Re: MTD Bartholomew Subdivision
UDC Sec. 35-506(r)(2)(C)

ADMINISTRATIVE EXCEPTION VARIANCE REQUEST ANALYSIS

Project: MTD Bartholomew Subdivision

| | MTD BARTHOLOMEW SUBDIVISION 1' VEHICULAR NON ACCESS EASEMENT EXHIBIT | | ISSUE DATE: _____ REVISIONS: _____ | SHEET: TEXT |

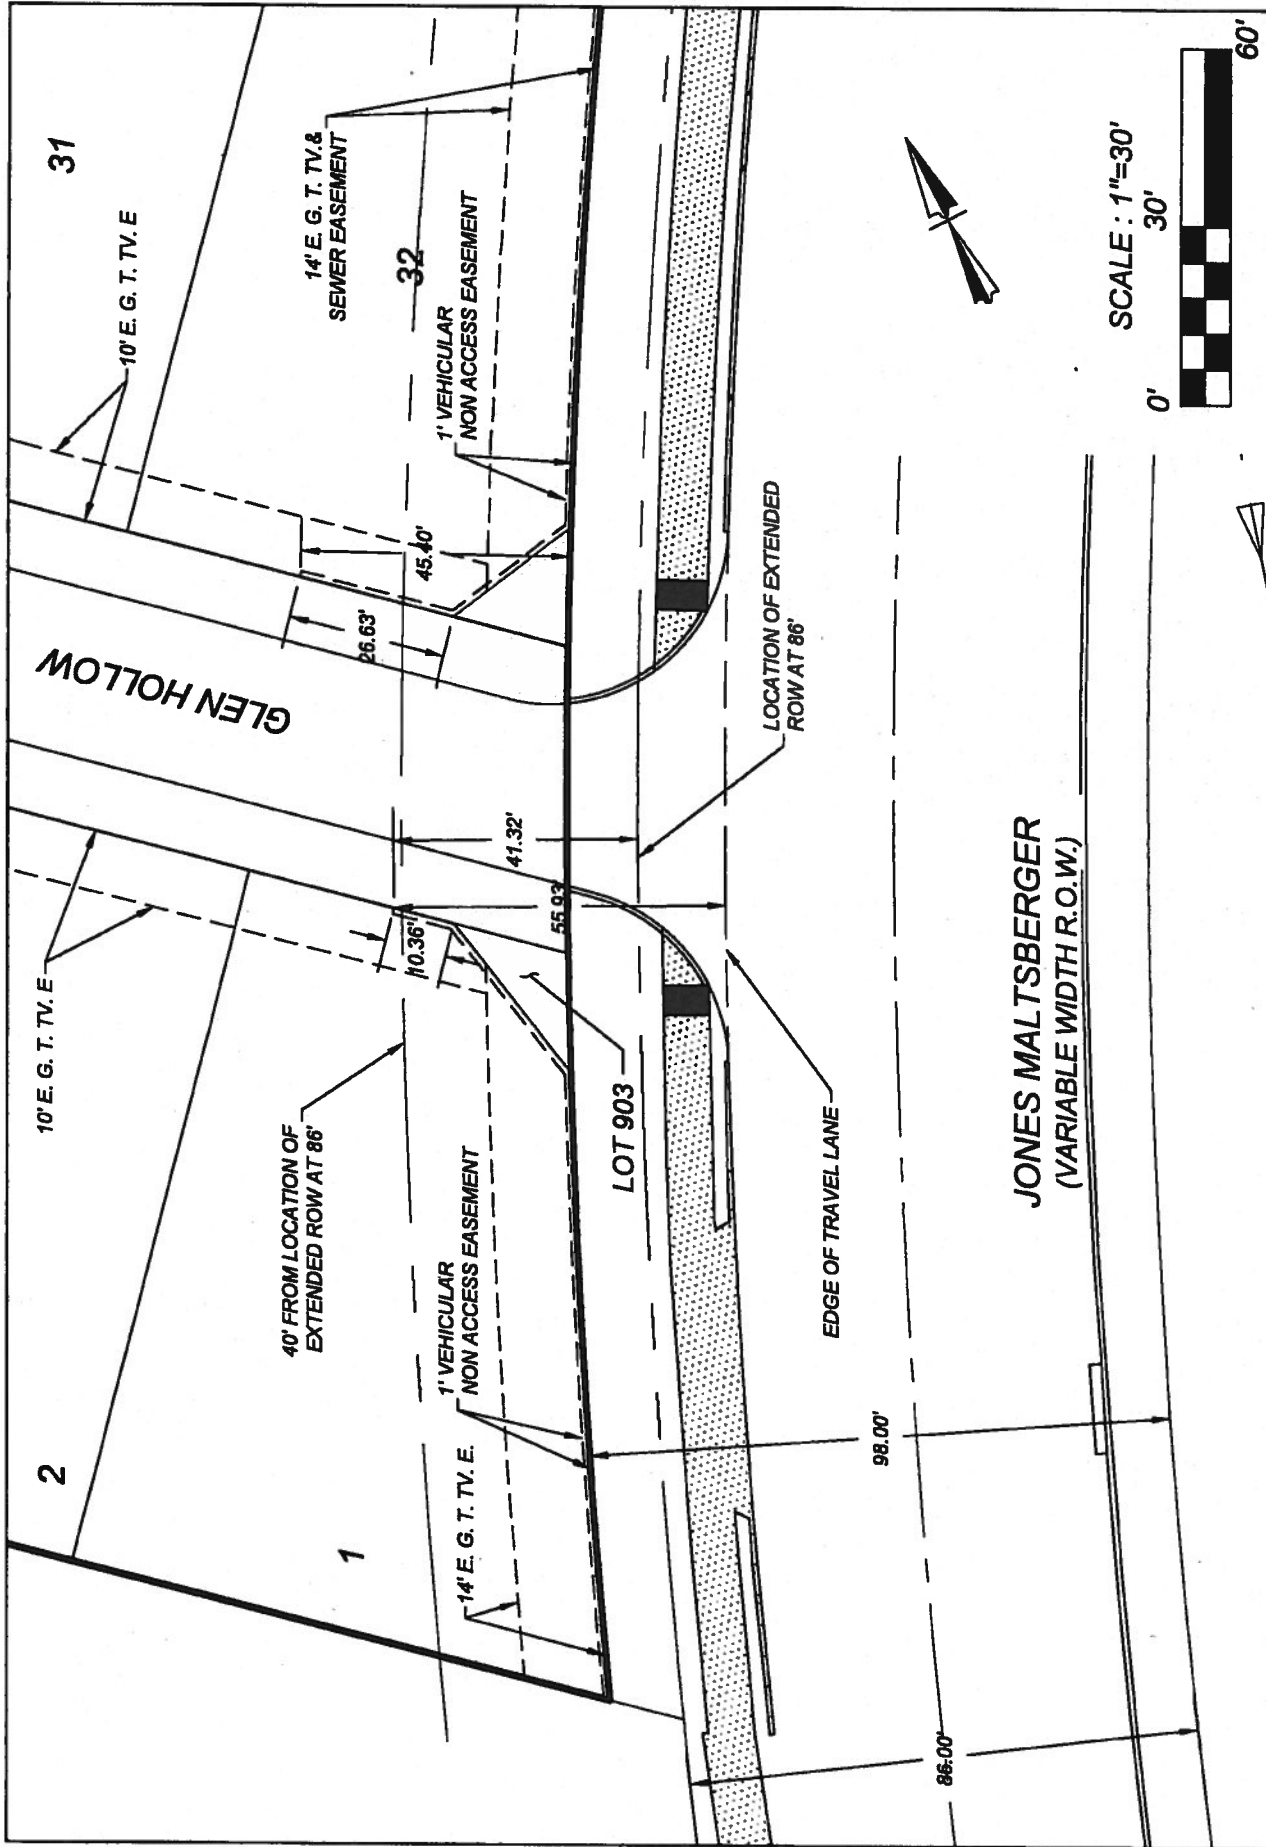
KFW Engineers has proposed a 1' Vehicular Non-Access Easement in the lots adjacent to the Jones Maltzberger Rd. right-of-way. This easement will require driveways to be placed a minimum of fifty (55) feet from the closest travel lane of Jones Maltzberger Rd. The proposed easement will provide a greater distance to the closest travel lane than the requirements of the Unified Development Code providing additional safety for vehicles traveling on the secondary arterial and entering the "Property".

The minimum width for a secondary arterial ROW is 86'. At the location of the proposed road (Glen Hollow), the width of the ROW is 98'. This provides an additional 12' of lane length to accept traffic into the subdivision. If the ROW width was 86' then the distance from the travel lane to the 40' offset of the ROW would be 53'. In order to meet this distance, KFW Engineers has extended the 1' vehicular non-access easement beyond the 40' offset from the extended 86' ROW line.

DSD staff believes the proposed variance does meet the intent of the UDC and is therefore supported. This approval is based on the agreement that the applicant is required to place a 1' vnae for 40 feet from the required 86' ROW instead of the property line.
